**ADDENDUM NUMBER TWO (2)  
TO THE PLANS AND SPECIFICATIONS FOR:**

**NORTH ECHS  
AND  
COLLEGE & UNIVERSITY CAMPUS  
STUDENT RESTROOM RENOVATIONS**

**PSJA ISD  
Bid # 18-19-042  
Project No. 19.04**

**GIGNAC & ASSOCIATES  
3700 N. 10<sup>th</sup> STREET, SUITE 205  
McALLEN, TEXAS 78501  
(956) 686-0100**

**ADD. 2  
A-140-N**

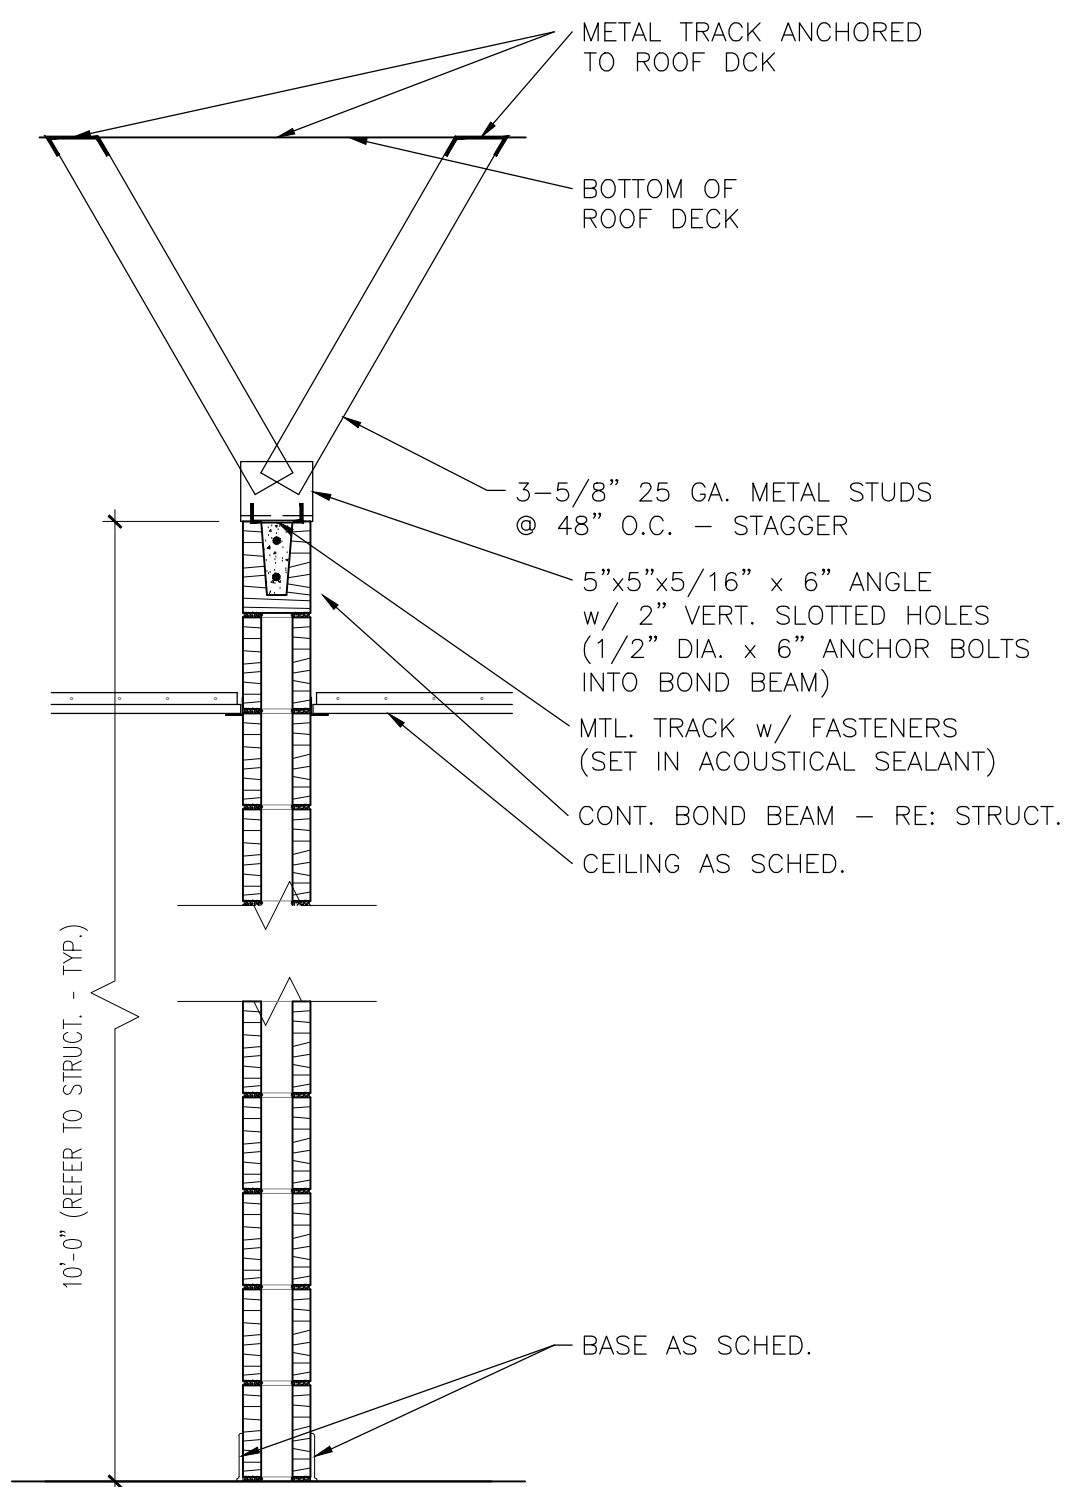
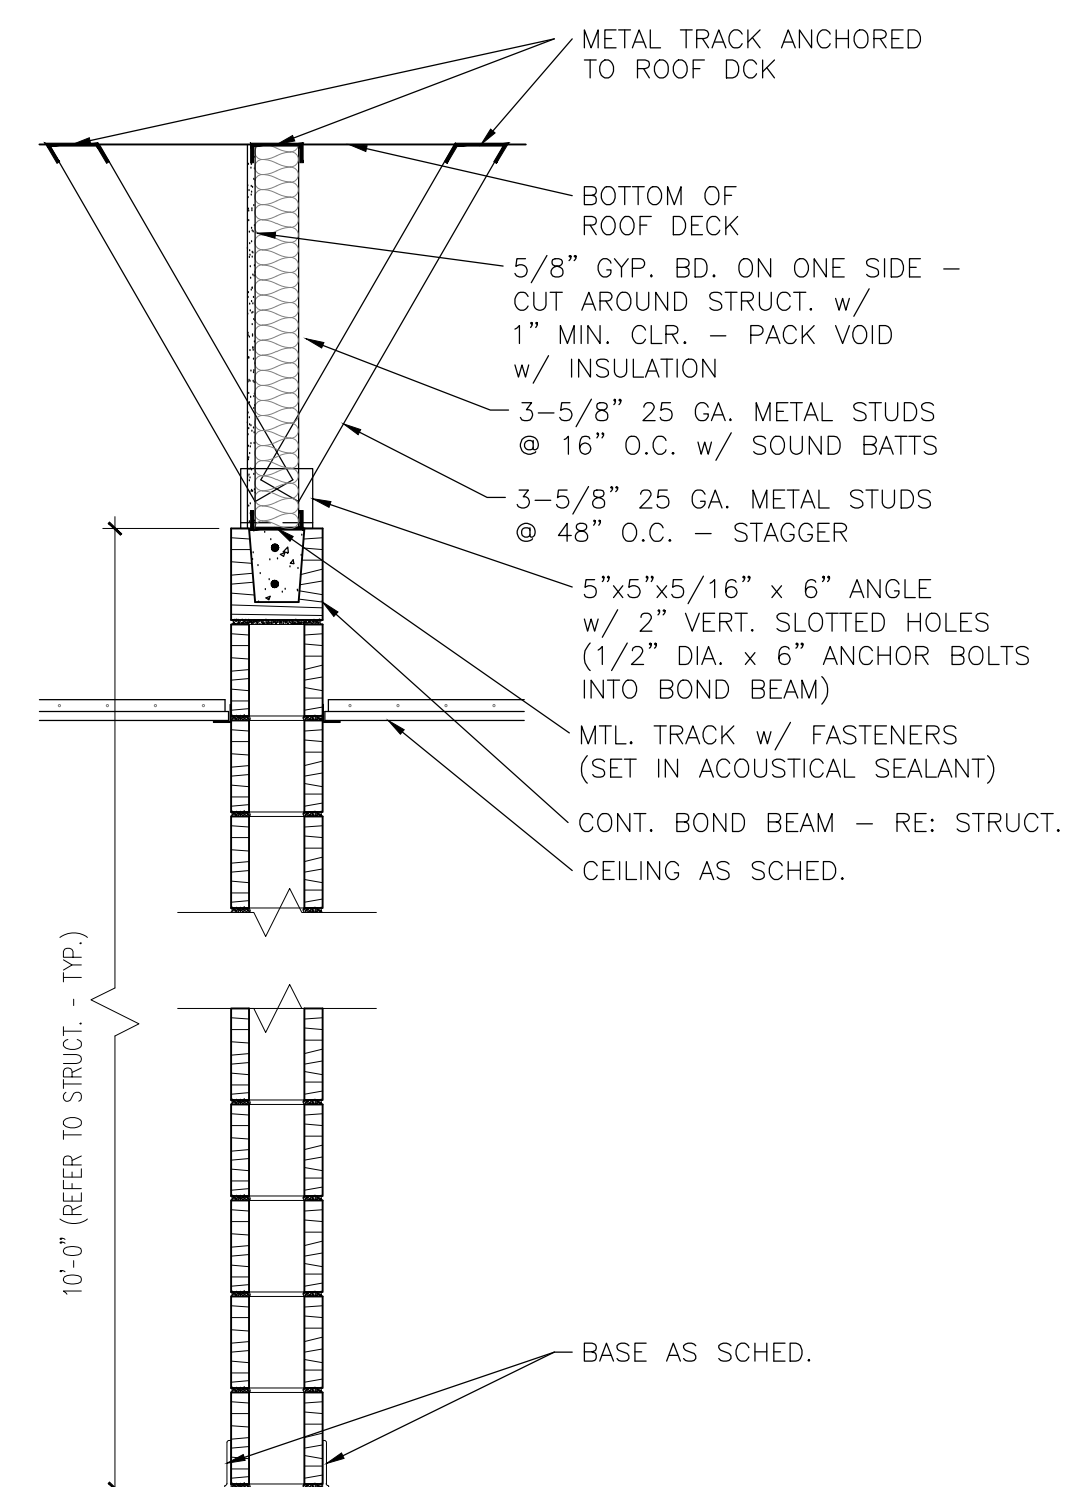
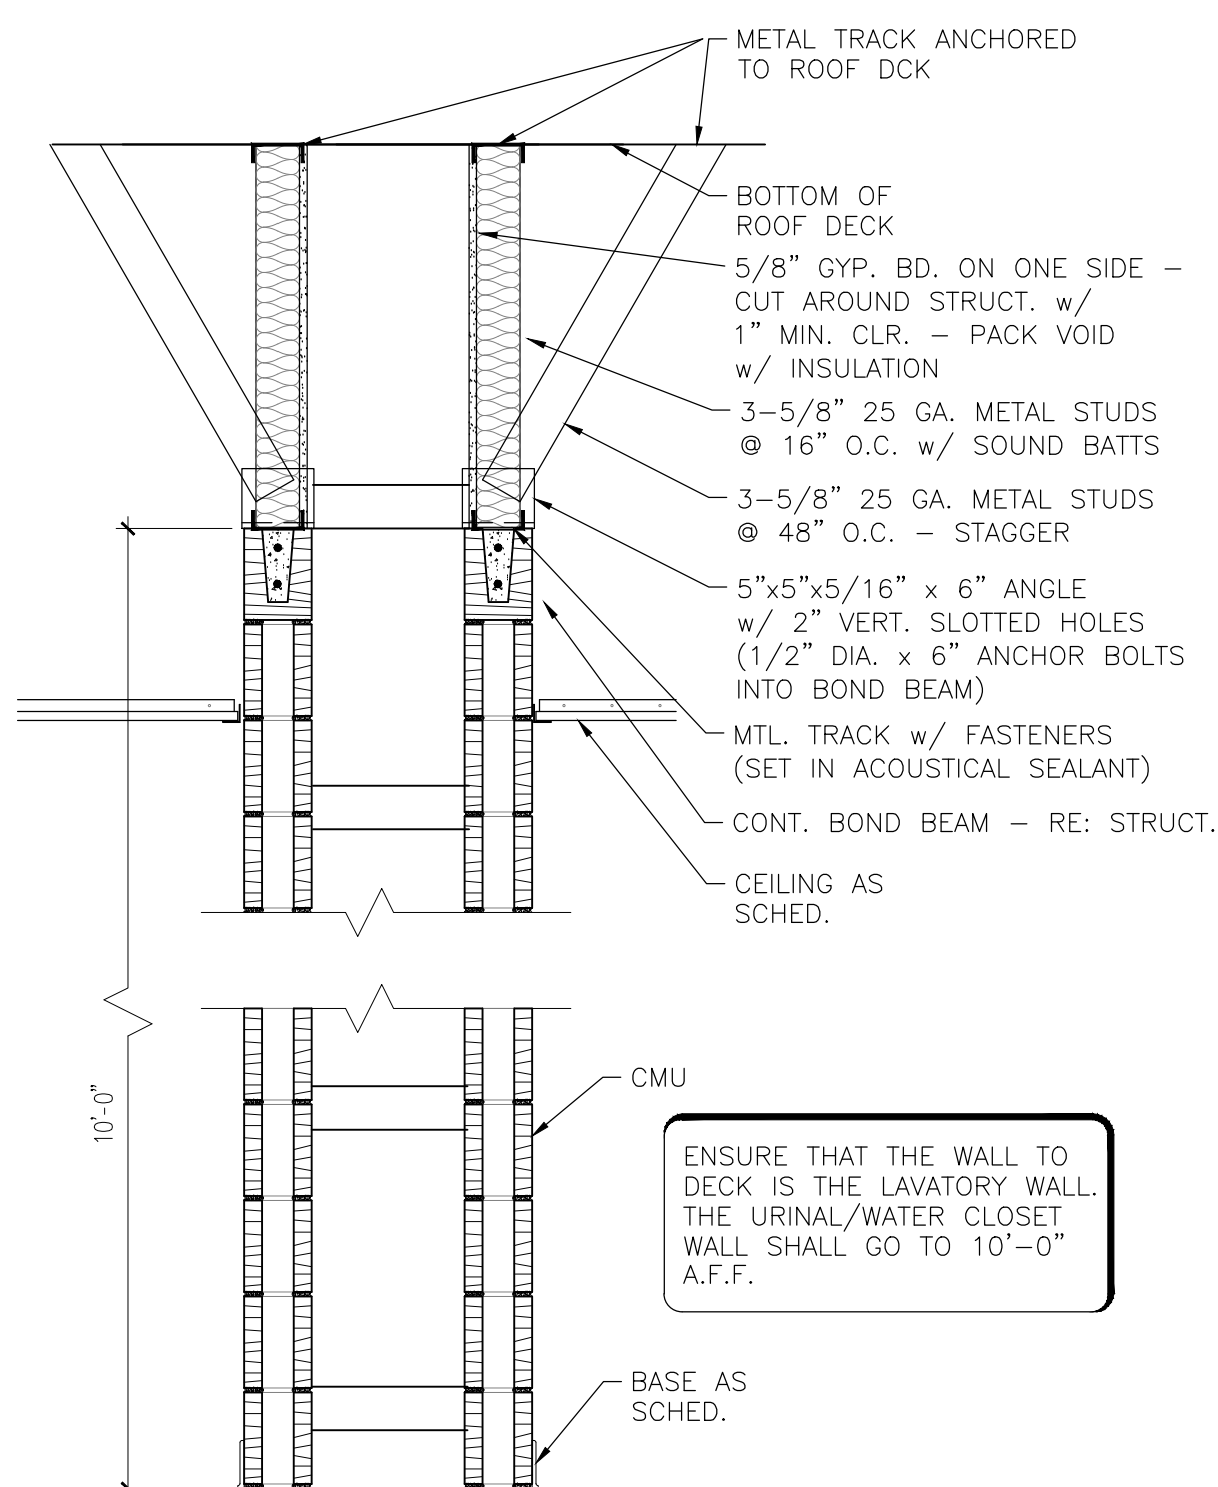
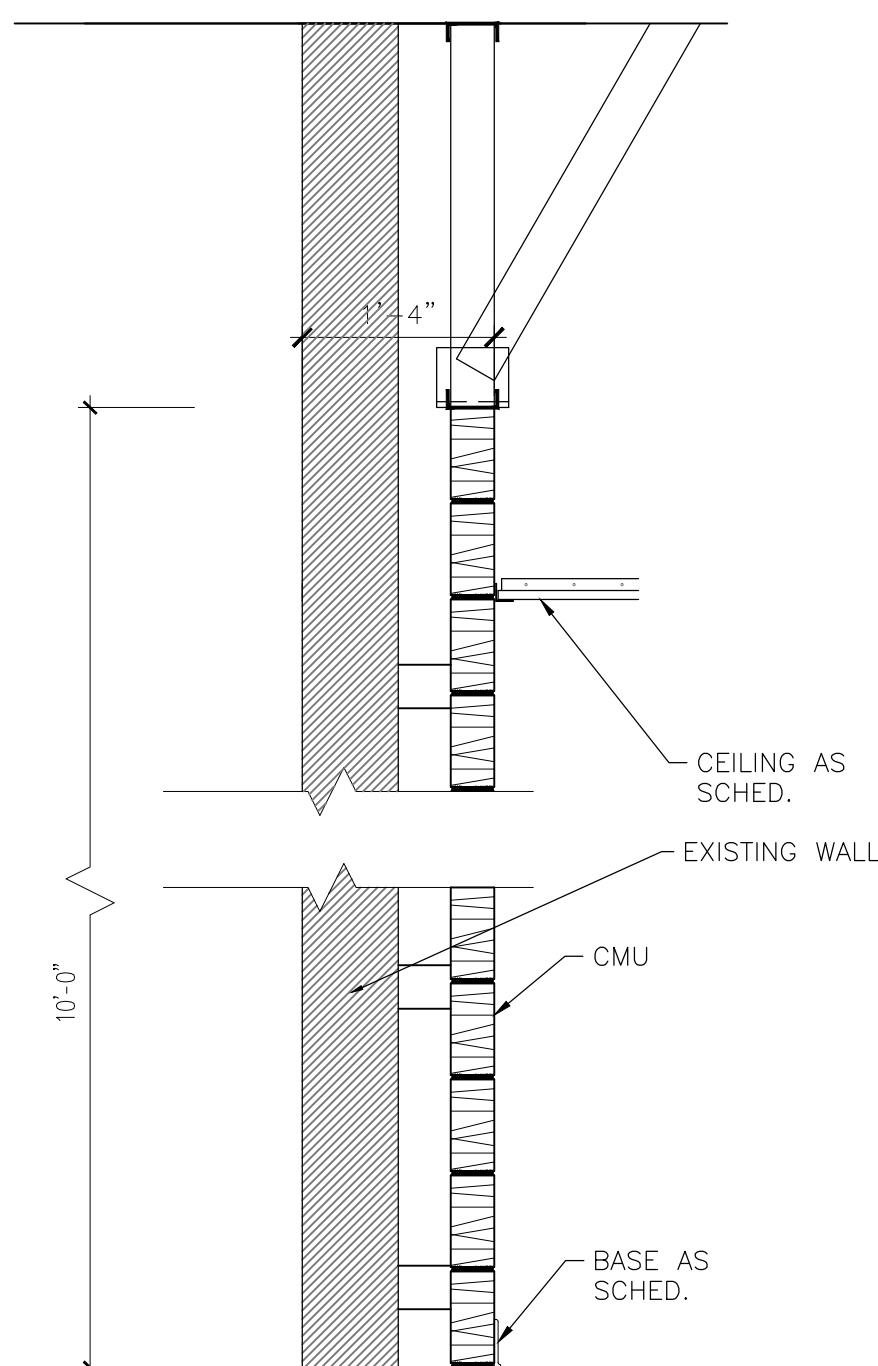
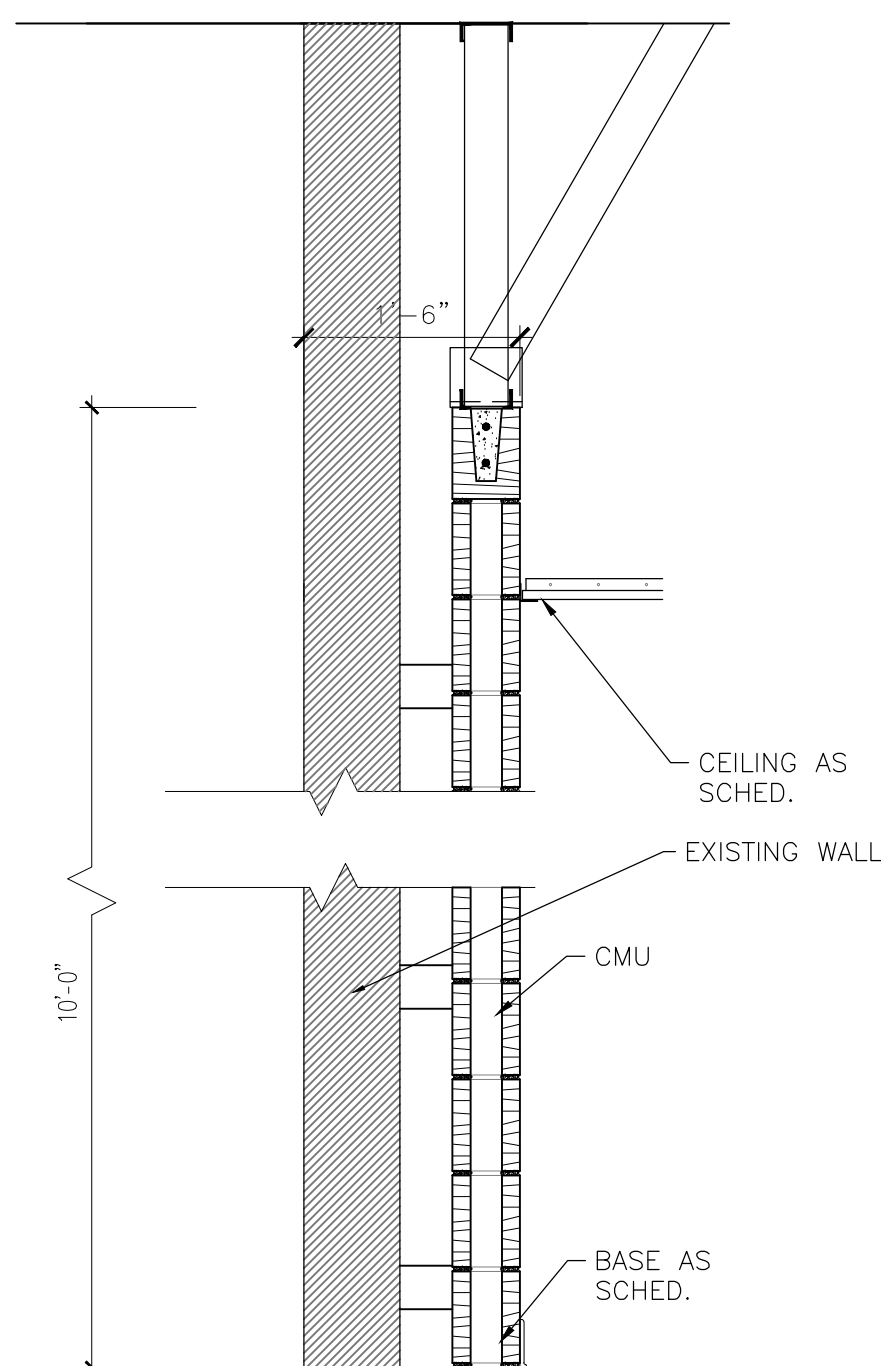
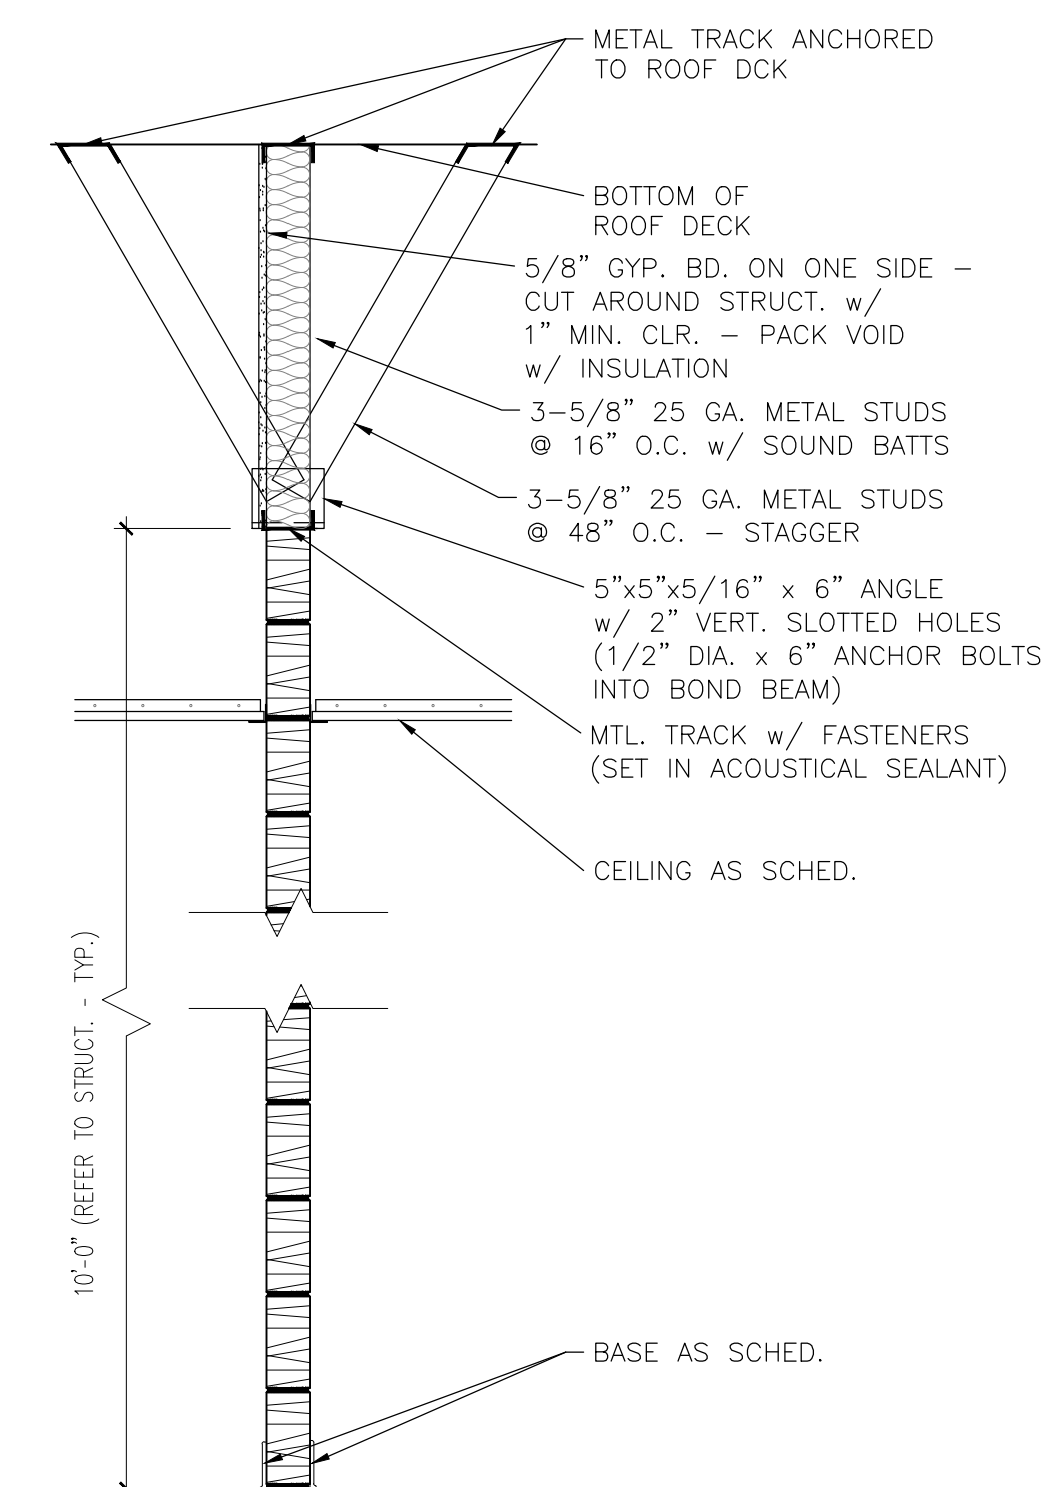
A-140-N (Wall Types) included in this Addendum shall be included as part of the Contract Documents. This sheet is to support the wall tags added in the Reflected Ceiling Plans in Item P-1.
